CERTIFICATE OF APPROPRIATENESS

Property: 1226 Heights Boulevard, Lot 19, Block 187, Houston Heights Subdivision. The property is a vacant 7,500 square foot (50' x 150') interior lot. Currently, the new two-story house approved by HAHC in July 2013 is partially completed.

Proposal: New Construction – Revision to COA for New Construction that was approved in July 2013.

PROPERTIES ALONG EAST SIDE HEIGHTS BOULEVARD

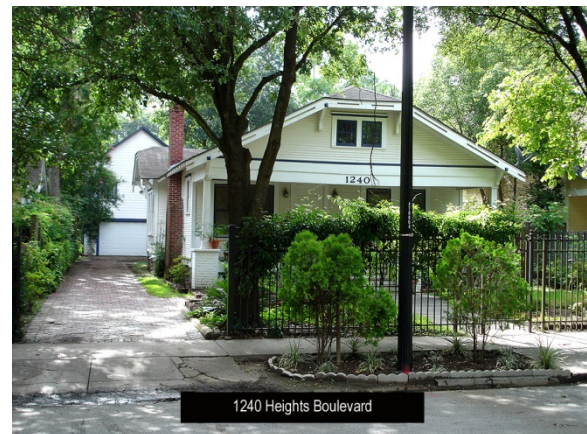
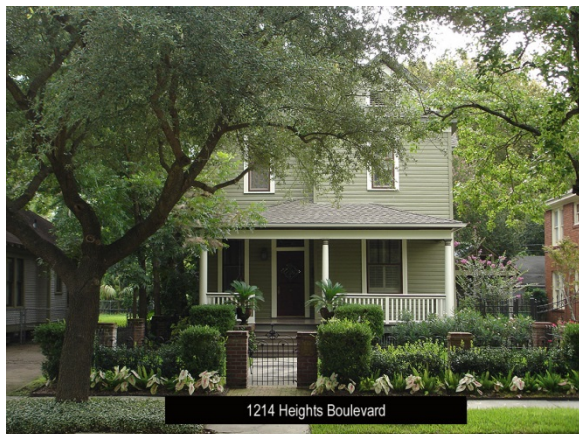
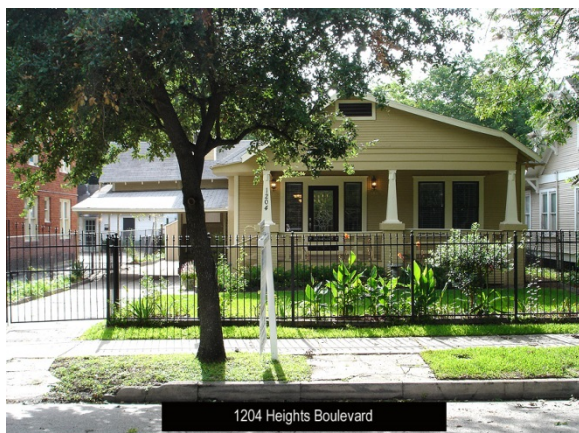
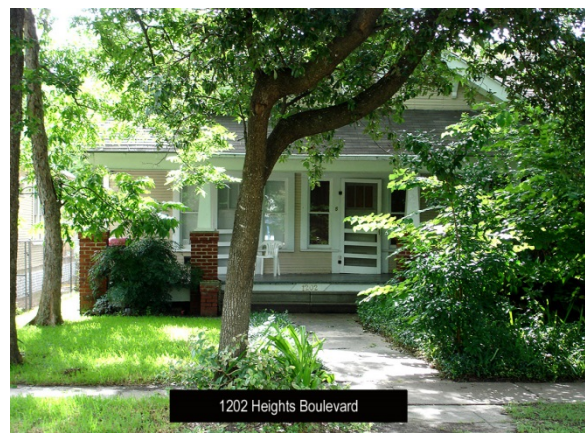
- ☐ ☒ ☐ (1) The new construction must match the typical setbacks of existing contributing structures in the historic district
- OPTION #2 does not meet this Criterion. All contributing buildings on this block of Heights Blvd are located at or behind the required 25' building line (see p.17). Encroaching on the 25' building line would put this structure out of line with the other contributing structures on this block of Heights Blvd, including the neighboring contributing historic residence at 1230 Heights Blvd.*

- Next door is a noncontributing building that is built well within the required 25' setback. This existing nonconformance should not be used as justification for a reduced setback for 1226 Heights Blvd. This noncontributing building could be demolished at any time and new construction would be required to be set back 25'. Also, Criterion 1 requires new construction to match typical setbacks of existing contributing structures. Noncontributing structures are not considered.*

PORCH LOCATION

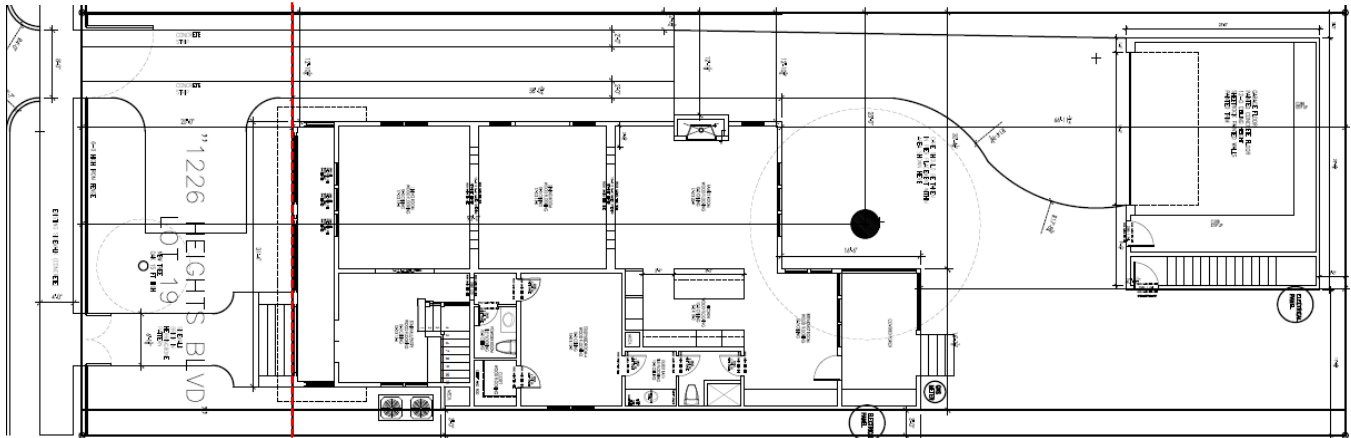
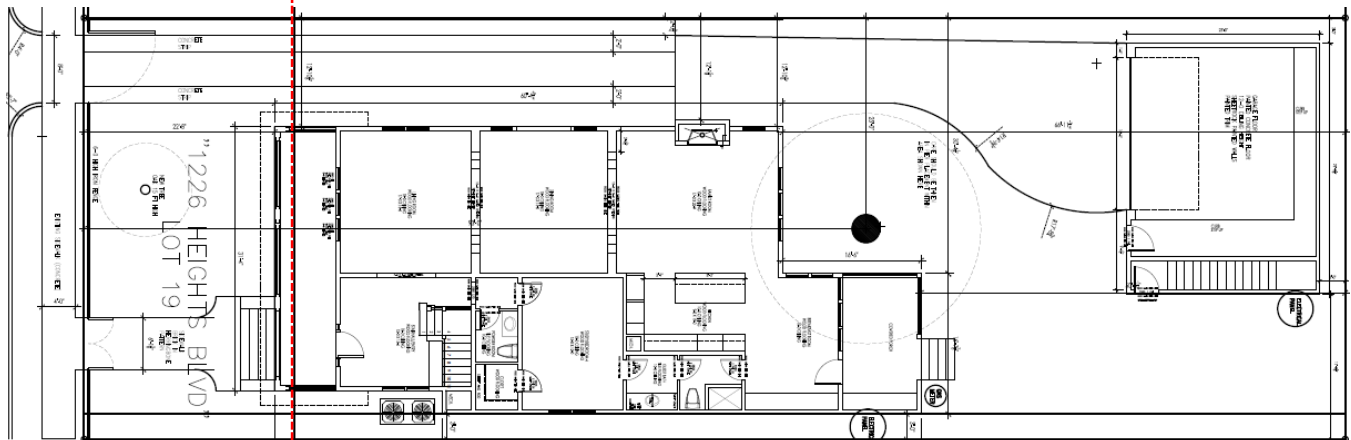
In December 2013, city staff became aware that the partially constructed house (framing and foundation only at that time – see p. 18) was built 2.2' forward of the approved location, which would put the front porch over the required 25' front building line when completed. A 25' front setback is required on Heights Blvd, which is a Major Thoroughfare. The error occurred because the construction crew measured the 25' front building line from a fence on the property instead of from the actual property line.

OPTION #1

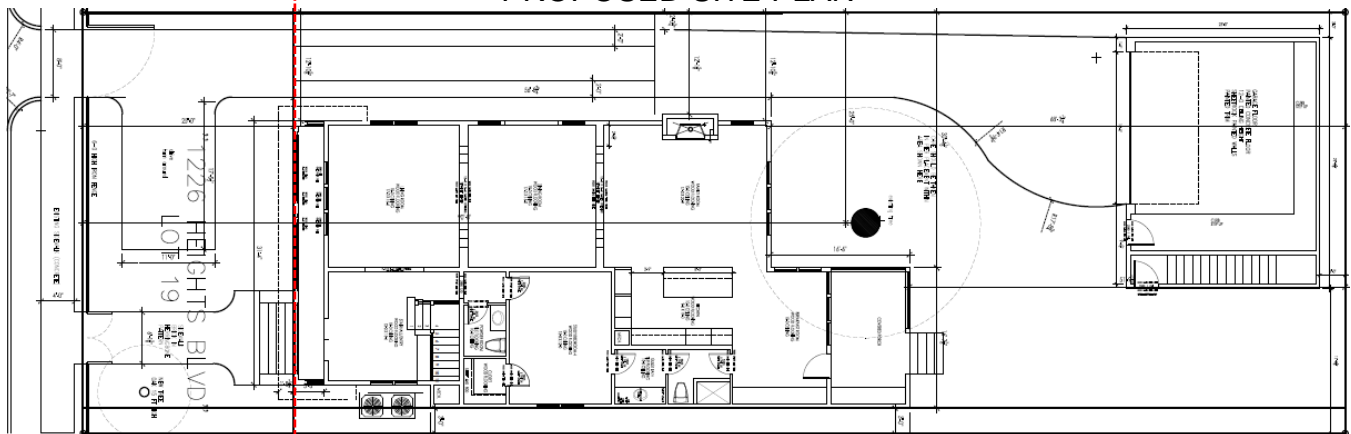
- OPTION #1 does not meet this Criterion. The proposed reduced porch depth of 3'-8" is not functional or typical to the district. Contributing historic houses in the Houston Heights Historic District East feature functional porches with depths of at least 6'-0". A porch with a depth less than 6'-0" would not be functional and therefore not typical.*
